Appearance Review Board Staff Report

ARB2018-10038

Agenda Item 1 — 336 N. Orange Ave. Orange & Robinson Apartments

East Elevation

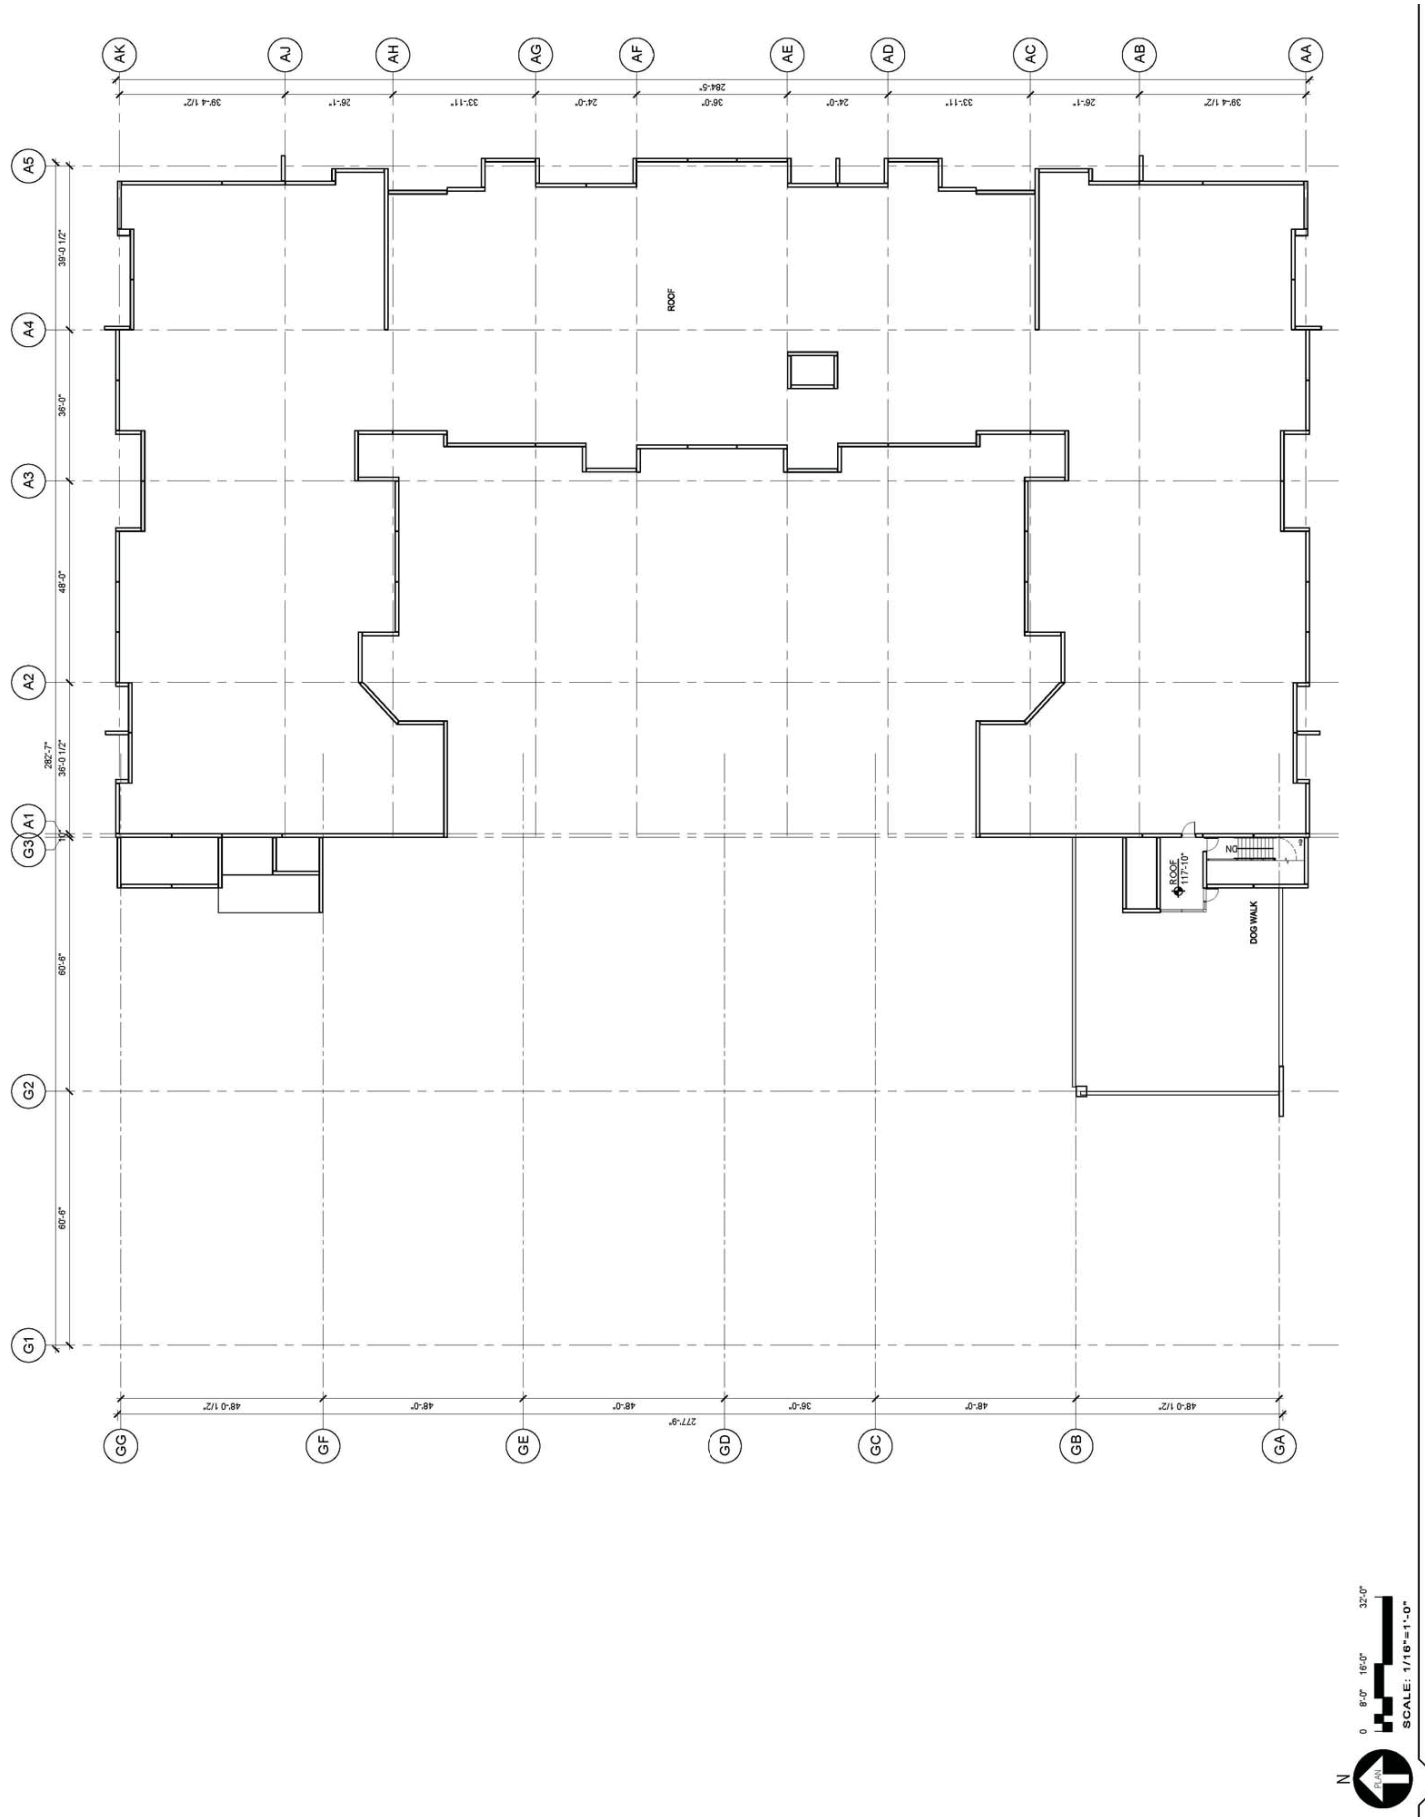
On the east elevation, the Orange Ave. façade, the addition of the 11th floor increases the skyline and street presence of the building. At the street level the masonry finish and extensive glazing begins to activate the Orange Ave. frontage. The inclusion of ground floor active social/commercial uses will complete the activation. The only weak element of the east façade is the central skyline element. ARB staff has collaborated on several projects with the architecture team in the past and is confident staff can work with the architect to increase the impact of the skyline element.

- B. Skyline Architecture – Additional attention needs to be paid to the skyline architecture along the Orange Ave. façade. The design team must continue to work with ARB staff to refine the design to staff's satisfaction prior to submittal of building permits.

South Elevation

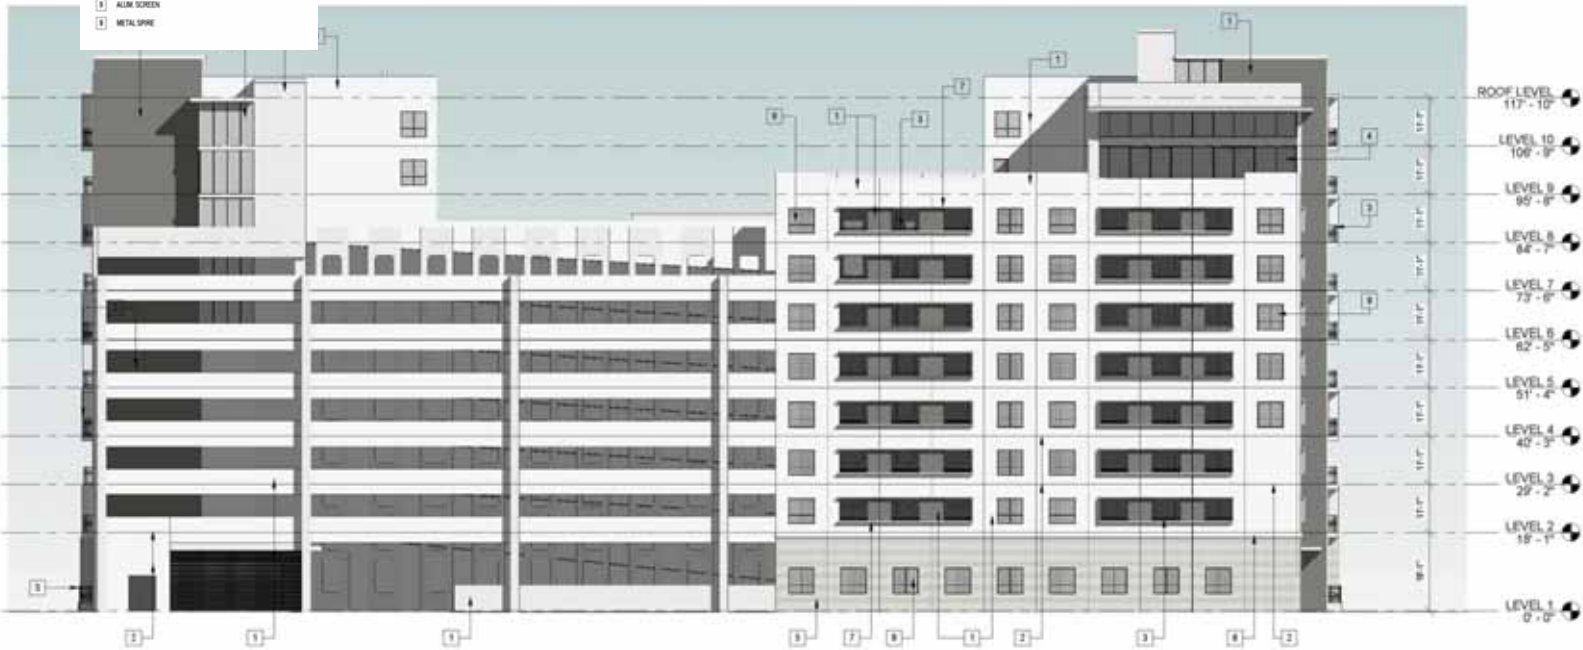
The south elevation that addresses Robinson St. has been improved as well. The addition of the 11th floor has added a step-down from Orange Ave. west to State Ln. that increases the visual interest at the skyline. The parking garage façade has been simplified and better organized, too. However, staff would like to explore connecting the darker vertical lines of the garage façade, with the design team, to determine if that move would better coordinated the garage façade with the stronger vertical lines of the east façade.

- C. Parking Garage—The darker vertical elements of the parking garage facades should be connected in order to make the treatment more consistent with the Orange Ave. façade.
